City of Mississauga

City Department and Agency Comments

Date Finalized: 2020-10-28 To: Committee of Adjustment	File(s): A341/20 Ward: 7
From: Committee of Adjustment Coordinator	Meeting date: 2020-11-05

Property Address: 421 Luzon Crescent

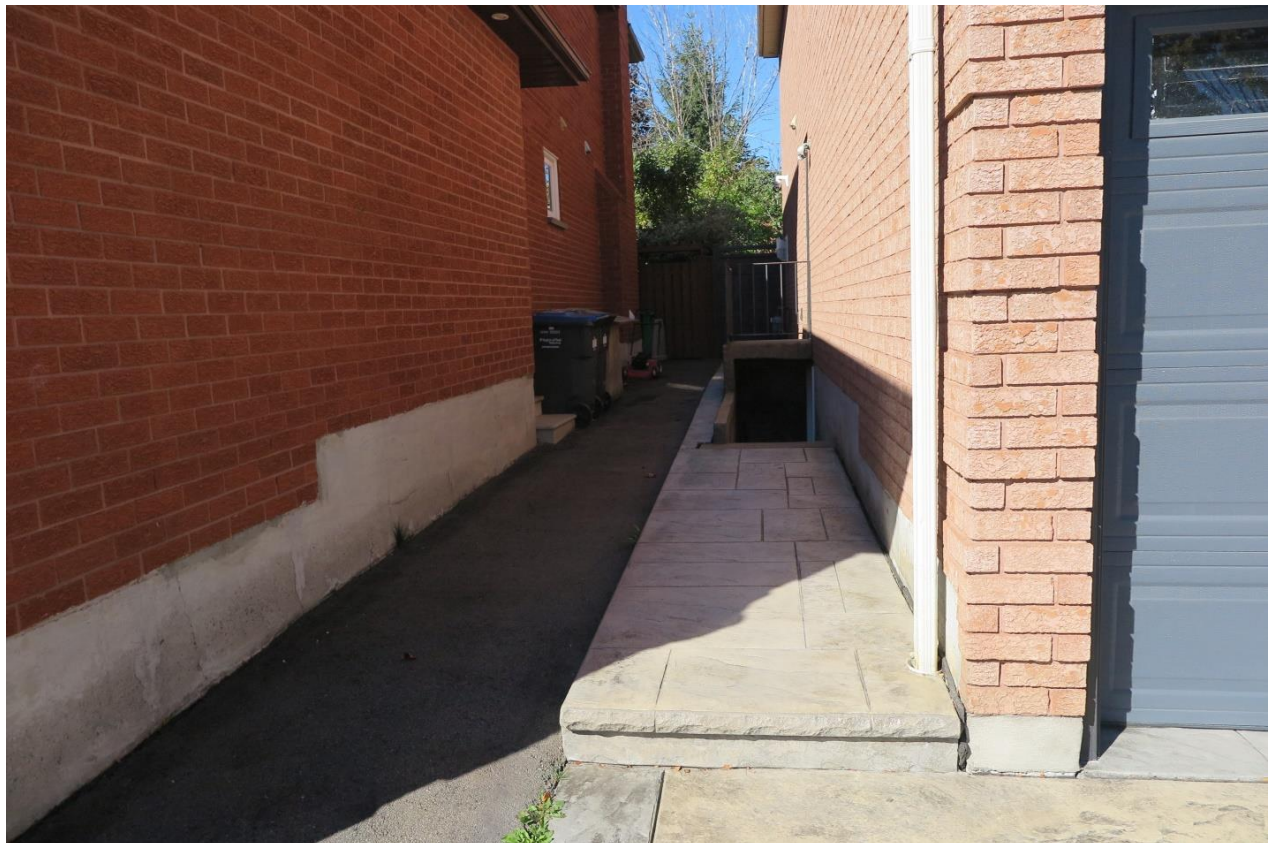
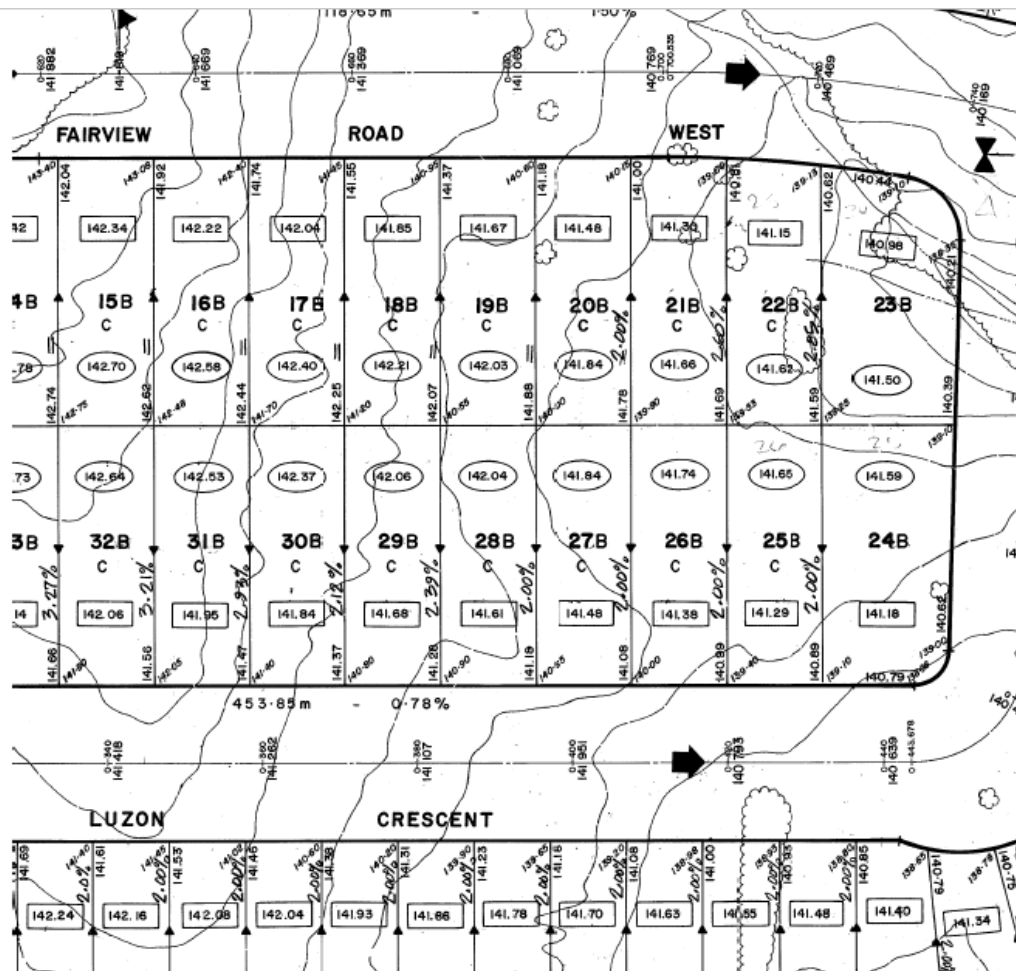
Enclosed for Committee's information are some photos which depict the existing basement entrance (below grade deck and stairs), as constructed. Also attached is the Grading Plan approved for this property under Registered Plan 43M-826 (Shown as Lot 29 B on Grading Plan C-24673 attached) which depicts a rear to front drainage pattern meaning drainage from the rear yard was designed to be directed to the front via side yard swale. A reduction in side yard setback to 0.18M (approx. 0.59 ft.) whereas 1.20M is required does not allow for a functional drainage swale between the properties and this would result in some drainage being directed onto the adjacent lot.
